Page 6 of 14 Appln. No. 10/077,665 Amendment

Amendment to the Drawings:

Fig. 5A

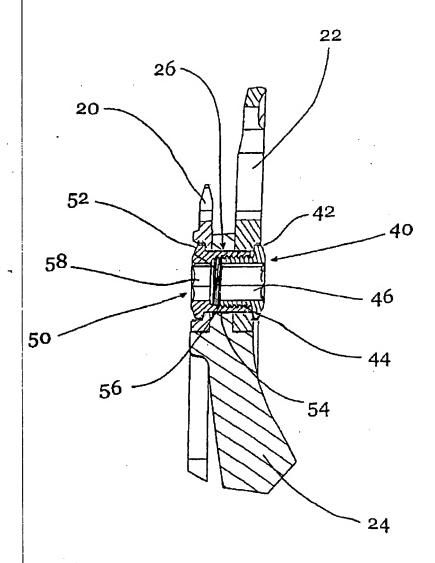
The attached sheet of drawings adds new Fig. 5A. Fig. 5A depicts an enlarged, fragmentary, radial cross-sectional view of the assembled nut and bolt fastener system, chainrings, and crank from Fig. 5 where the tool interface 46 of the bolt 40 faces outside of or towards the crank handle. Further, Fig. 5A shows the tool interface 58 of the nut 50 to be of substantially the same size as the tool interface 46 of bolt 40.
